10 March 2021

SECTION 4.55(1A) MODIFICATION APPLICATION Sydney Metro Martin Place Station Precinct – North Site (SSD 9270) MOD 5

Figure 1 Approved placement of louver

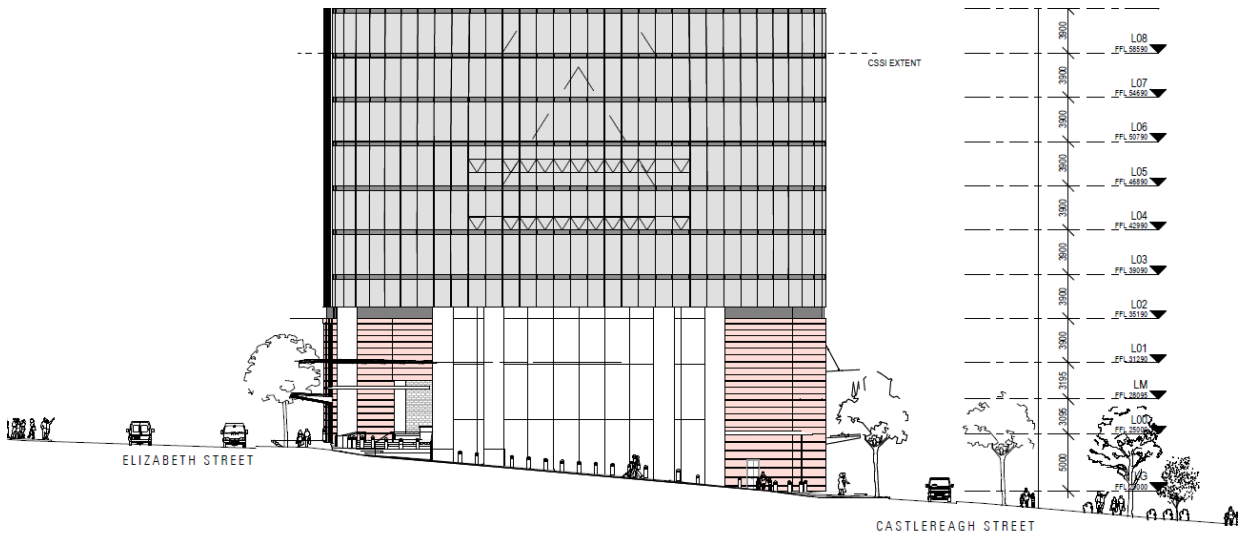
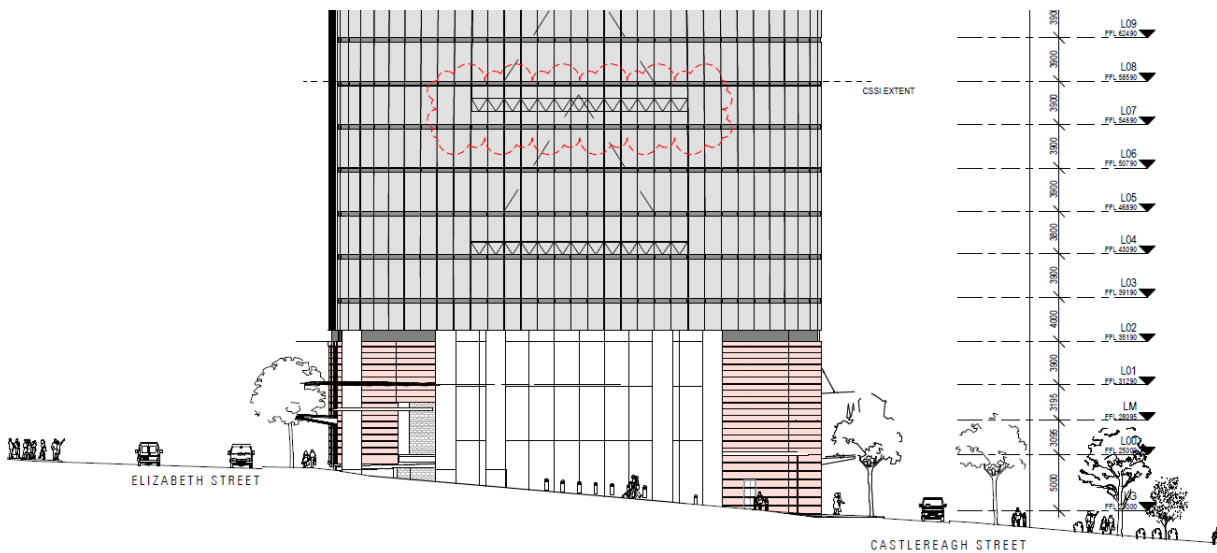
The approved design of the northern elevation of the tower incorporates operable windows for atrium smoke exhaust and make up air. Since approval, Macquarie has developed their fit-out requirements and now requires the relocation of the smoke exhaust and make up air operable louvres from Level 5 to Level 7. **Figures 1** and **2** show the approved and proposed location of the louvres.

Figure 3 Approved central atria

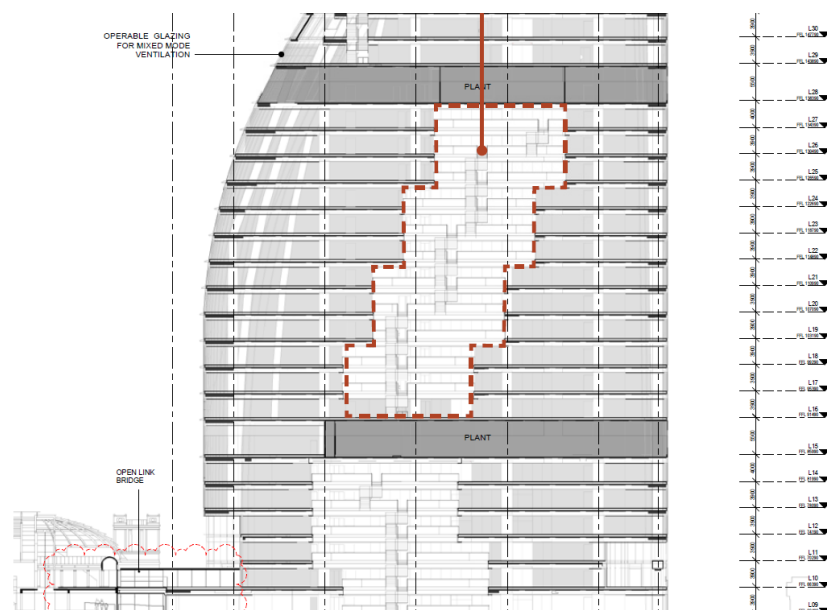
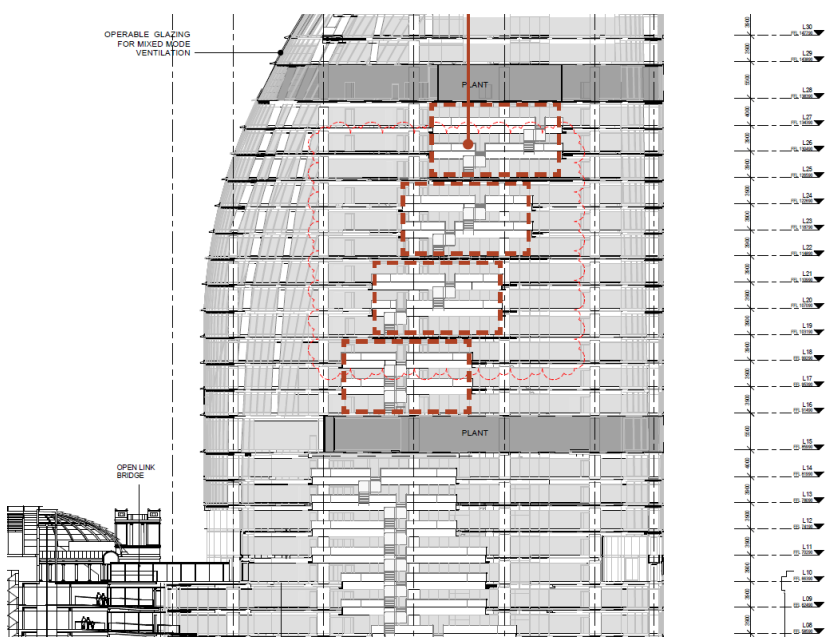
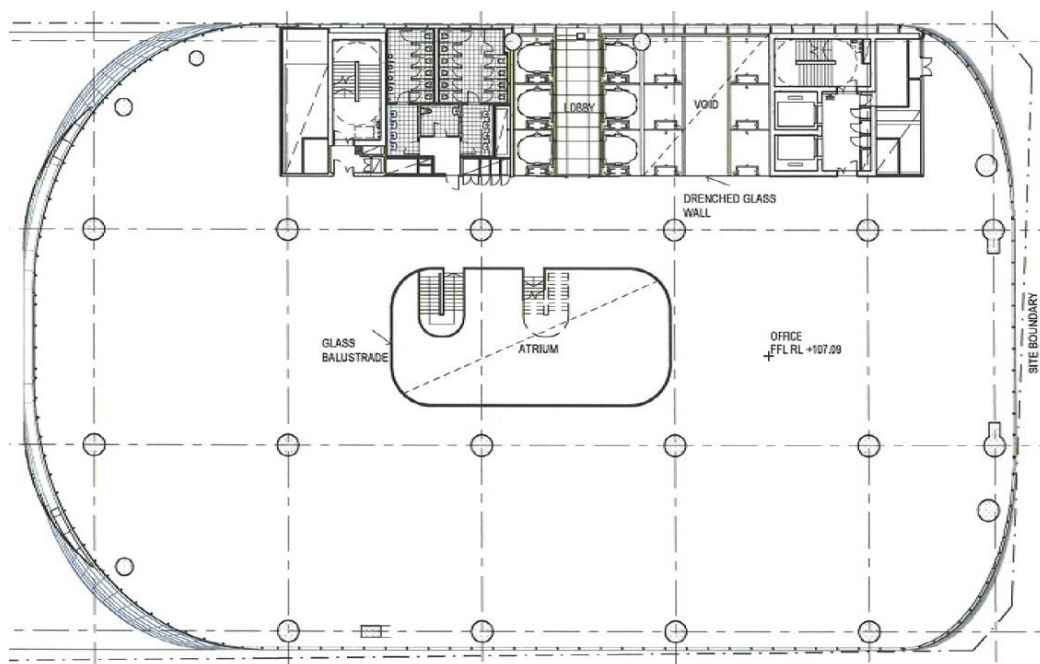
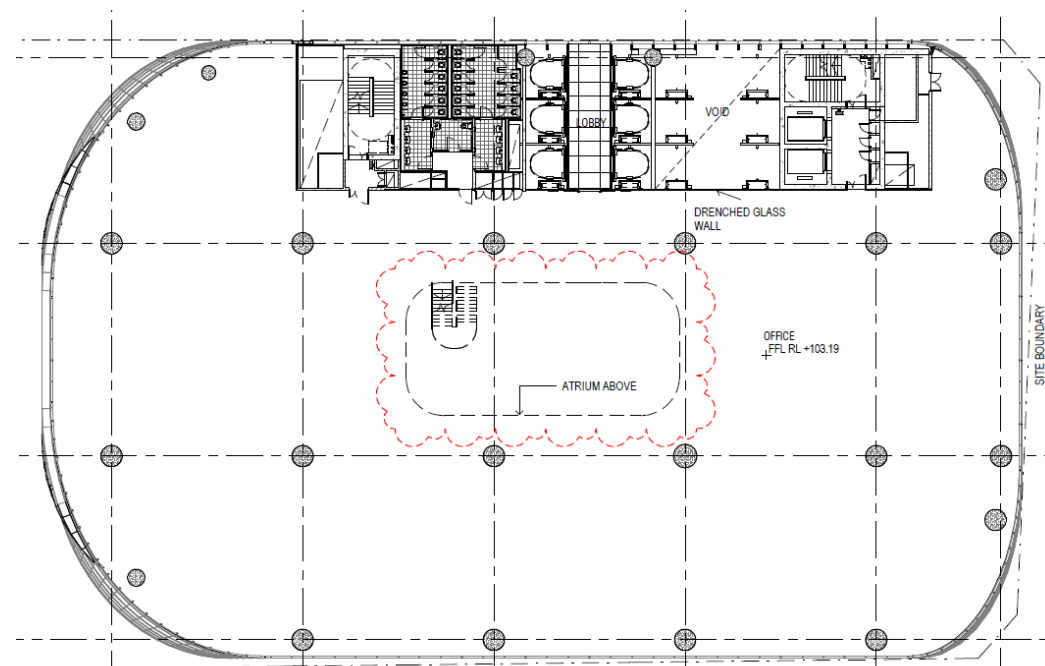
The approved development incorporates central atria within the low and mid rise sections of the tower. Since developing their workplace design, Macquarie proposes to fill in the atria previously approved on Levels 19, 22 and 25 to provide a series of four individual central atria that each connect three workplace floors. A comparison of the approved atria and proposed atria is illustrated in **Figures 3 and 4** respectively. An example of the proposed infilling on Level 19 is shown below in **Figure 6** (the same is proposed on Levels 22 and 25). The slab infills will result in an additional 176m² of commercial GFA on Level 19, 175m² on Level 22 and 176m² on Level 25, resulting in a total overall GFA increase of 527m².

Figure 7 Approved Level 29 Amenities core

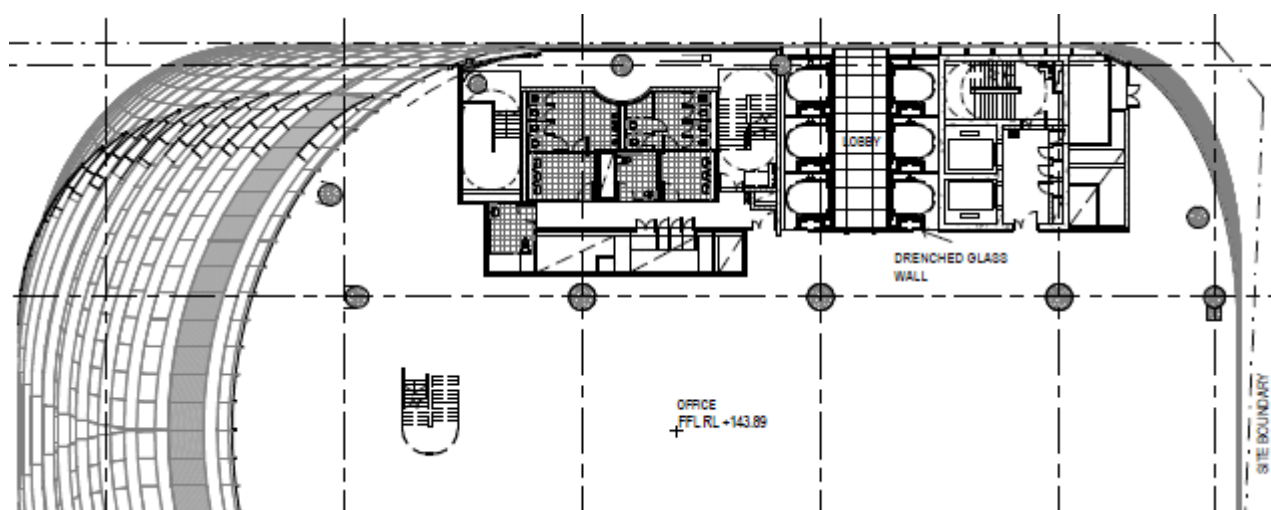
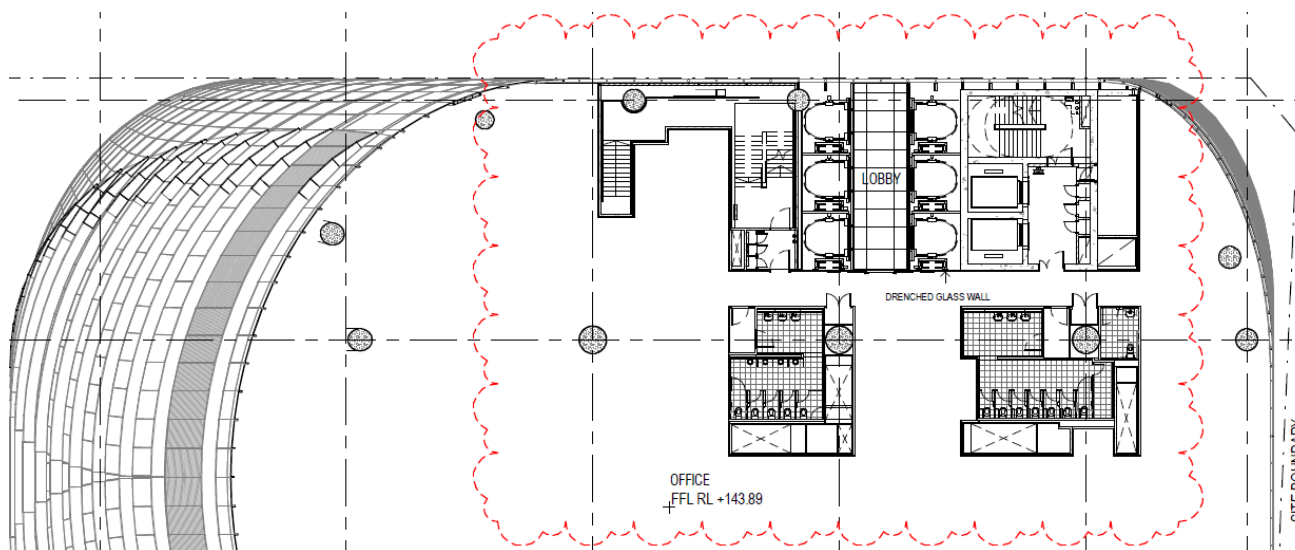
The approved high rise floors incorporate amenities and services within the western core block. Since approval, Macquarie have developed the high rise building design and servicing has been rationalised to reduce the extent of the core to the south-west and north-west. As such, the amenities and services have been relocated away from the south west façade to stack vertically from Level 29-37 and achieve more consistent workplace floor plates across the levels. The changes are contained entirely within the proposed building, and as such will not have any impact on the built form as previously approved. The re-arrangement will lead to a minor total increase of 239m² GFA across levels 29-37. The proposed changes are typical of the evolving design development process and are considered an improvement to the approved development from a functionality and useability perspective.
